ADDENDUM 2

RE: 000I-289, McCook County – PCN I6VD
Sign Repair along I90 from MRM 356.00 to 367.00

ERECTION DETAILS
FOR
**TWO-POST TWO-DIRECTION
BREAKAWAY SIGN SUPPORTS**
S. D. DEPT. OF TRANSPORTATION
DECEMBER 2016

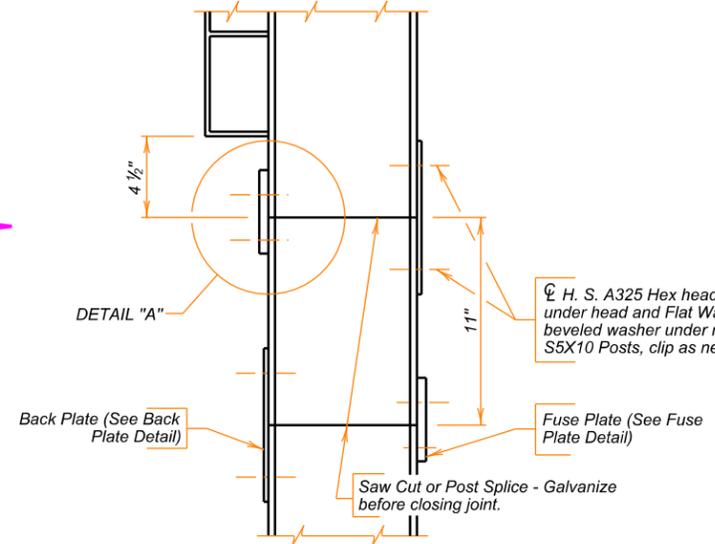
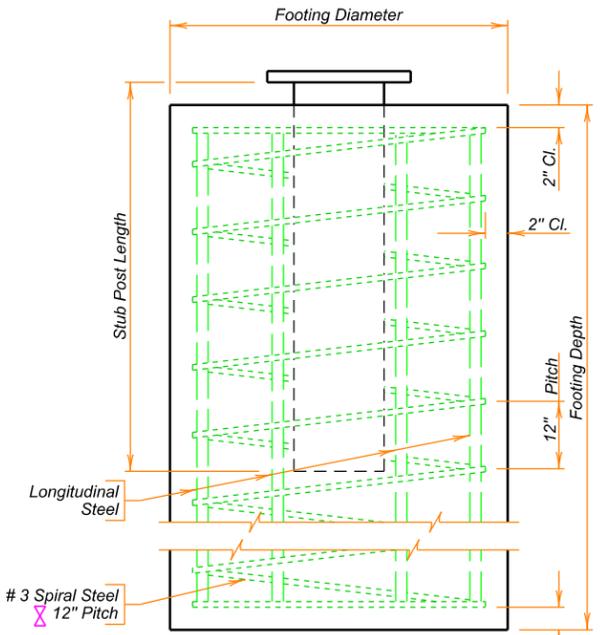
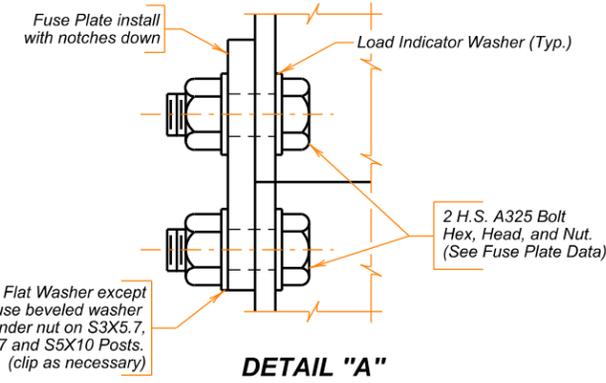
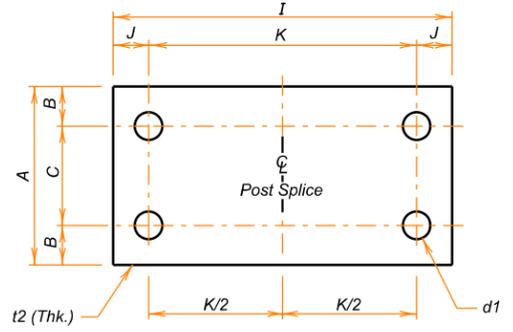
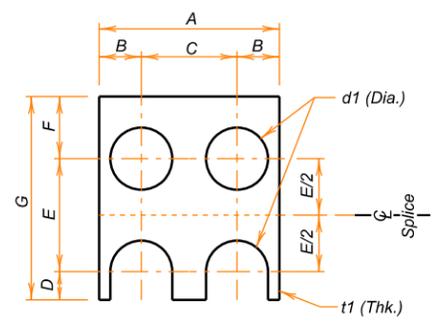
Remove and discard existing Sheet 9 of 11 and replace it with the enclosed revised Sheet 9 of 11.

The Footing Diameter was revised to 1'-9" in the table.

ERECTION DETAILS

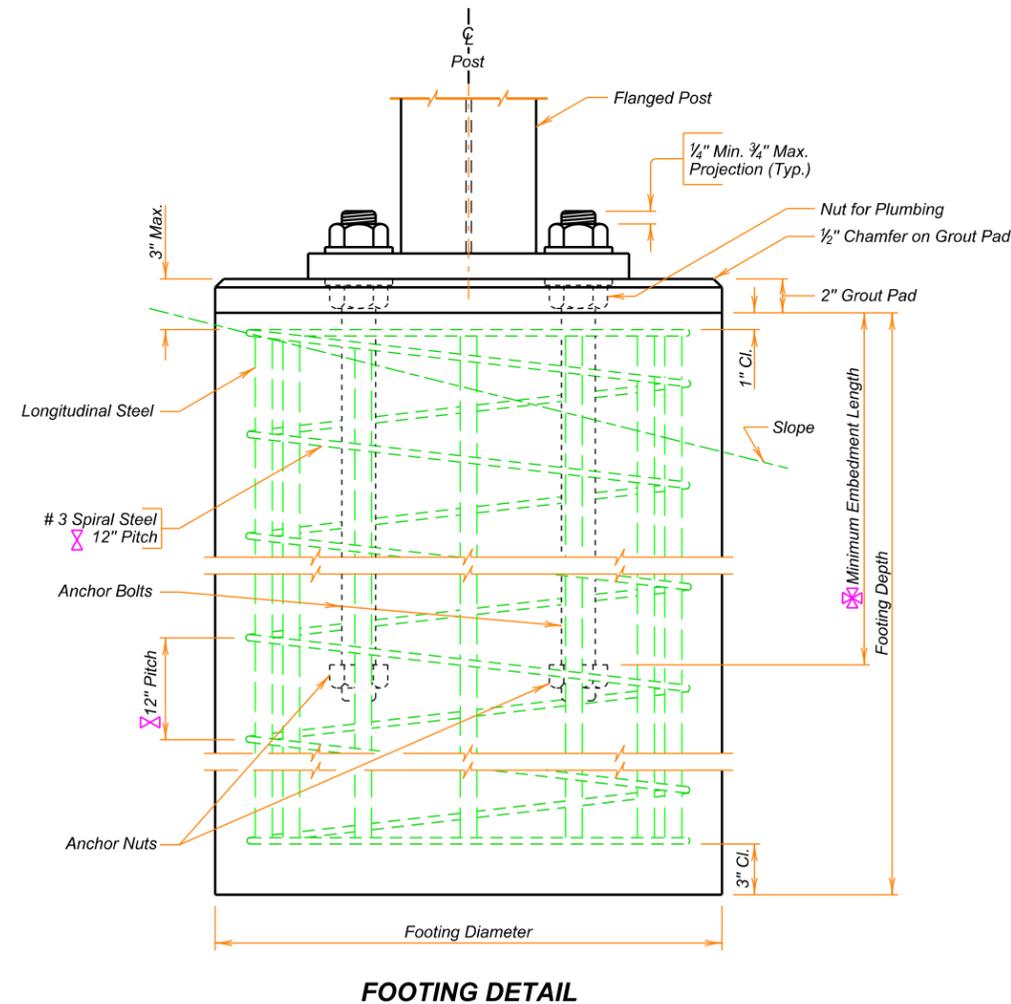
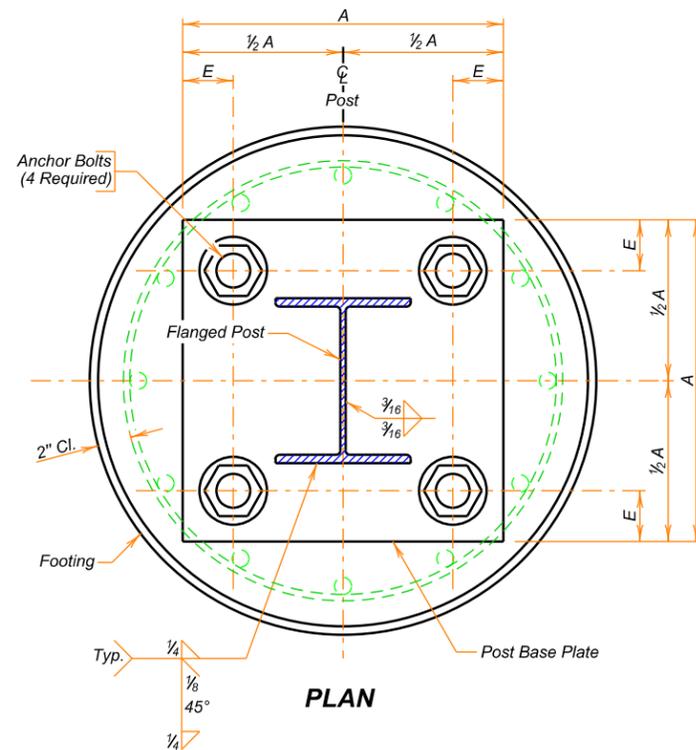
Three interstate sign assemblies had posts changed from reuse to new posts. Related post and footing information was revised for these sign assemblies.

In the Fixed Sign Support Table, at I90 WB MRM 359.00+0.395, the text was revised from as reads: "EXIT 357 / Bridgewater / Canova Arr." to read: "EXIT 357 / Bridgewater / Canova 1 MI".
